4. TITLE AND SUBTITLE: HYDRAZINE BLENDING AND STORAGE FACILITY, WASTEWATER TREATMENT AND DECOMMISSIONING ASSESSMENT, TASK 34, TECHNICAL PLAN, VERSION 3.2
5. FUNDING NUMBERS

HYDRAZINE BLENDING AND STORAGE FACILITY
WASTEWATER TREATMENT AND DECOMMISSIONING ASSE

RESPONSE TO COMMENTS

RESPONSE TO U.S. ENVIRONMENTAL PROTECTION AGENCY COMMENTS
(DATED MAY 14, 1987) ON TASK 34 TECHNICAL PLAN

Figure 1-4.
 SCHEMATIC LAYOUT, HYDRAZINE BLENDING
 AND STORAGE FACILITY
 ROCKY MOUNTAIN ARSENAL, TASK 34
 Prepared by EBASCO Services, Incorporated

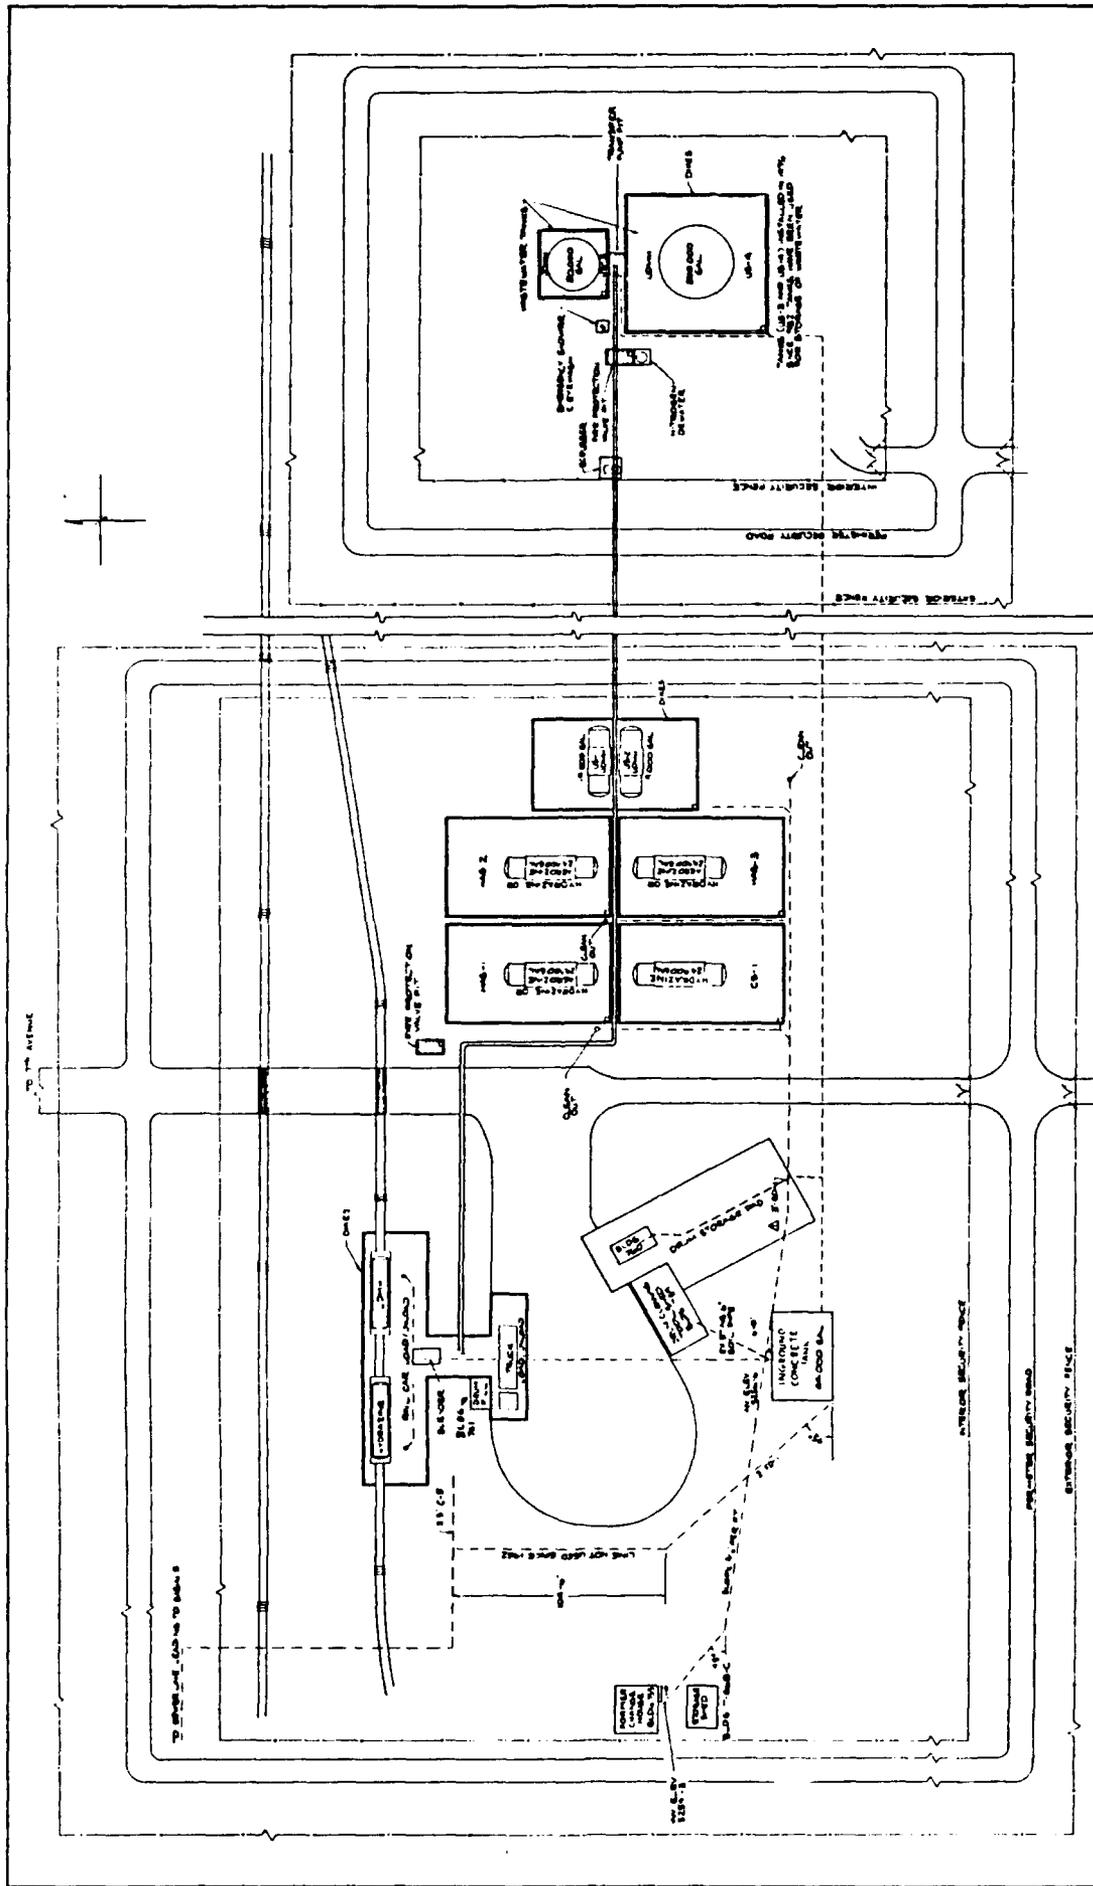
3. Figure 1-4 - No drain lines are shown from the drum storage pad to the in ground concrete storage tank. Are there any facilities to catch spills, or drum wash water?

Figure 1-4--No drain lines are shown from the drum storage pad to the inground concrete storage tank. Are there any facilities to catch spills, or drum wash water?
